Product Change Notification: PCN-22-141452 PCN Date: 08-JUN-22

General Product Description:	
USB 3.0 TYPE A/B RECEPTACLE STANDARD TYPE R/A,VERTICAL MTG THRU HOLE

Soft Tray material change from PVC to PET

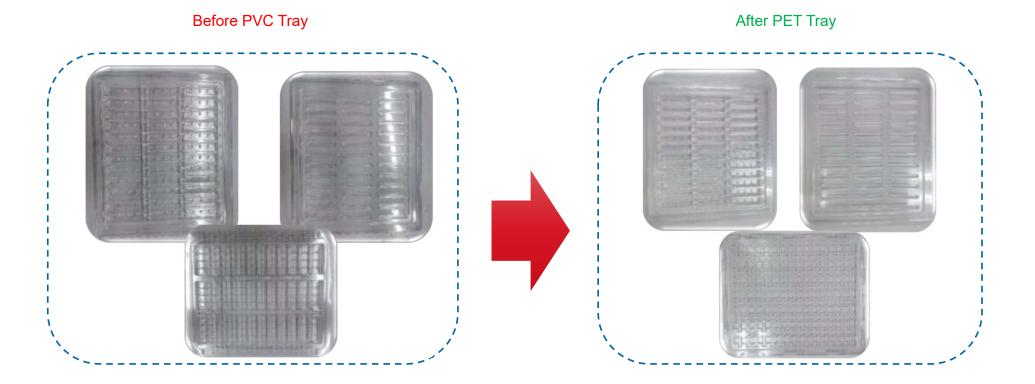
Soft Tray material change from PVC to PET.

To change the Soft Tray material from PVC to PET and some customer do not use PVC in packaging material to respond to the "the Packaging regulation" from customer.
